# City of Alexandria, Virginia

## MEMORANDUM

**SUBJECT:** 220 SOUTH UNION STREET  
BAR CASE #2014-0037 and 2013-0321

Figure 1. PREVIOUS three building scheme (L) and CURRENT two building scheme (R)

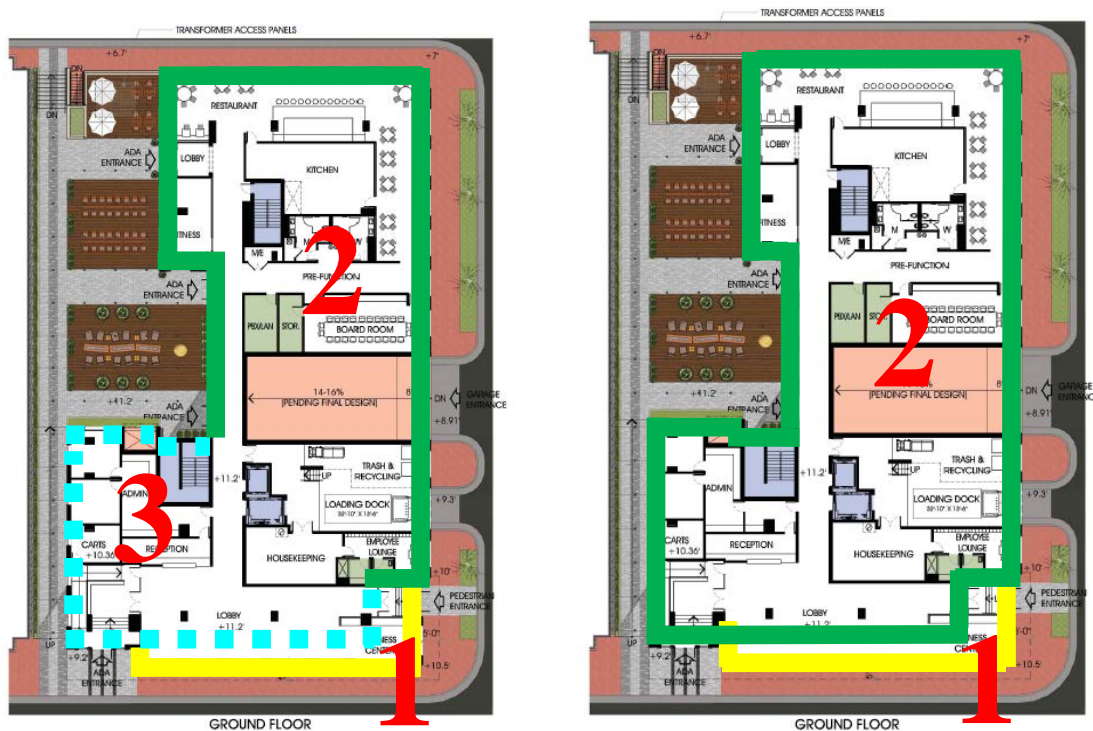
In the continuing effort to simplify the overall design, the project is now a clear two building configuration, as opposed to the previous three building scheme. The design retains the three-story red brick building element on South Union Street and combines what had previously been identified as buildings 2 and 3. Previously, building 3 was not well connected with the overall scheme and it was challenging to reconcile how it fit into the overall scheme. Adding a third brick color for that element resulted in a less harmonious and unnecessarily complex design.

DUKE STREET - WALL SECTION AT MANSARD ROOF

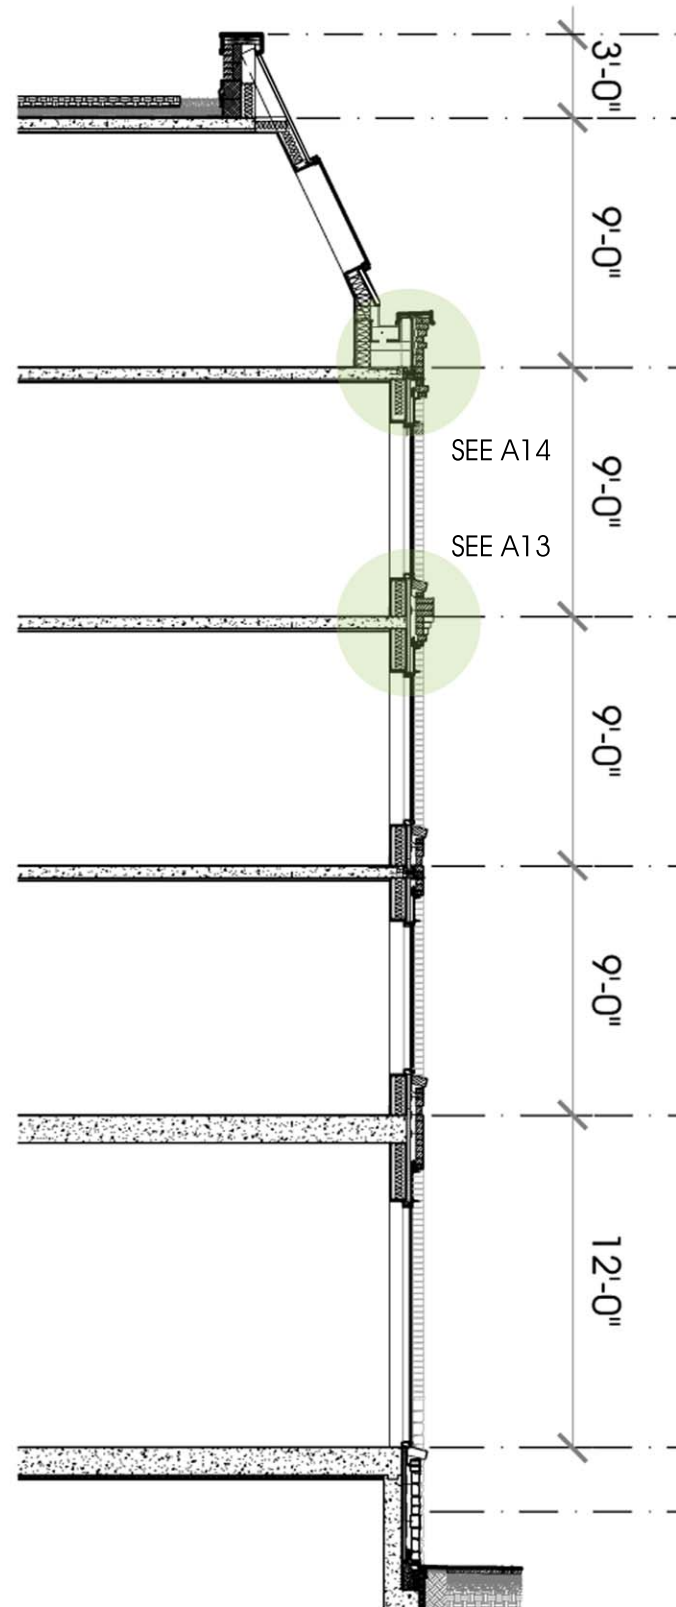
The wall section for Duke Street shows that the pitched roof will clearly be set back from the façade behind a cornice and gutter to allow the building to read as a four-story building with a clearly defined frieze at the 4<sup>th</sup> story and a pitched roof with shallow roof windows above. The details and sections of the cornice and corbelling indicate a depth and projection consistent with historic elements. Staff is satisfied that these building wall sections and masonry details ensure a well-proportioned, high-quality, appropriately detailed building and recommends approval.

PROPOSED EAST ELEVATION - STRAND STREET

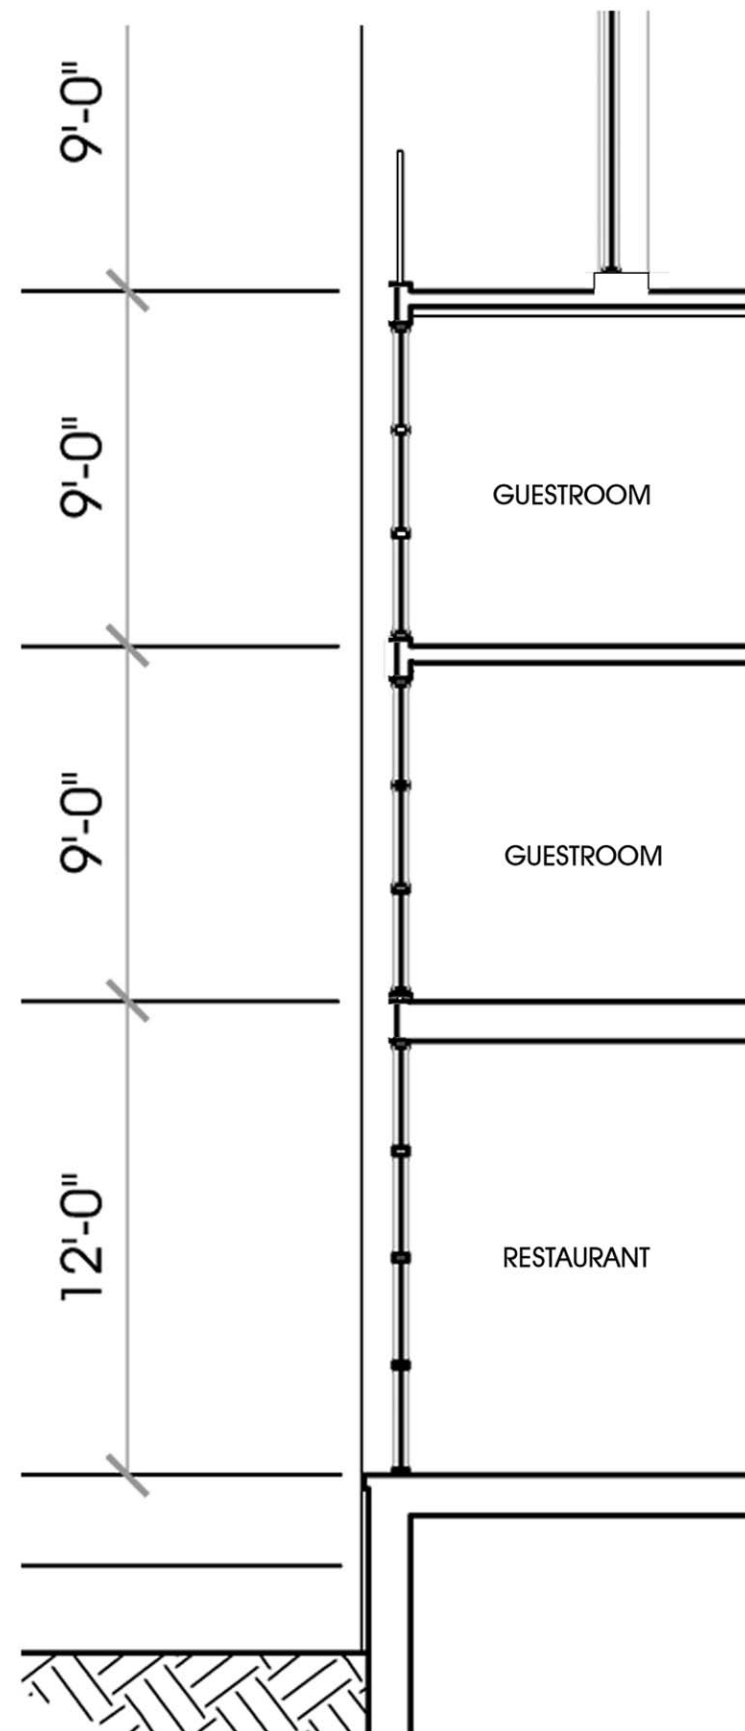
The Board has always focused on this elevation due to its prominence and visibility from the Potomac River and the future waterfront park. The applicant has been encouraged to showcase this elevation and promote a dialogue between the hotel and the park in this location. This elevation is an opportunity for operable windows, architectural lighting and innovative signage. The applicant studied the use of French doors for all the upper stories, with glass or metal railings, however their preference, stated at the work session, was for a two-story grouping of windows with spandrels between and only to have French doors with glass railings at the first floor. The Board members supported this design. In addition, the top of the lanterns (3<sup>rd</sup> story) will now have glass guardrails, as opposed to the previously shown metal pipe railings. The current scheme reflects the Board's work session comments.
